Access Compliance Report Public Rights-of-Way (Curb Ramps)

Intersection ID: 14714 Main Street: E MOREHEAD ST Cross Street: HARDING PL Location: W **Overall Compliance: No Severity Score:** 25 ADA ID: BDCF0462E63A Ramp Type: Combination2 Initial Pass/Fail: Fail

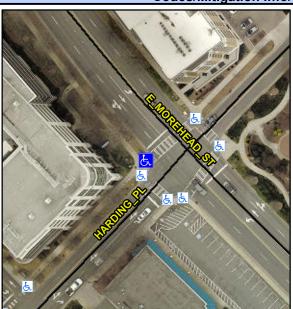
Street 1 Name Signal Stop Condition-Street 1 **E MOREHEAD ST** N/A Street 2 Name Stop Condition-Street 2 N/A Possible Solutions: Compliance Description N/A Remove & Replace Entire Ramp. N/A N/A N/A N/A Yes Surveyor Notes: N/A N/A N/A N/A N/A N/A PROW/ADA: N/A Not Found, R304.5.3, R304.3.2 N/A N/A N/A N/A N/A N/A
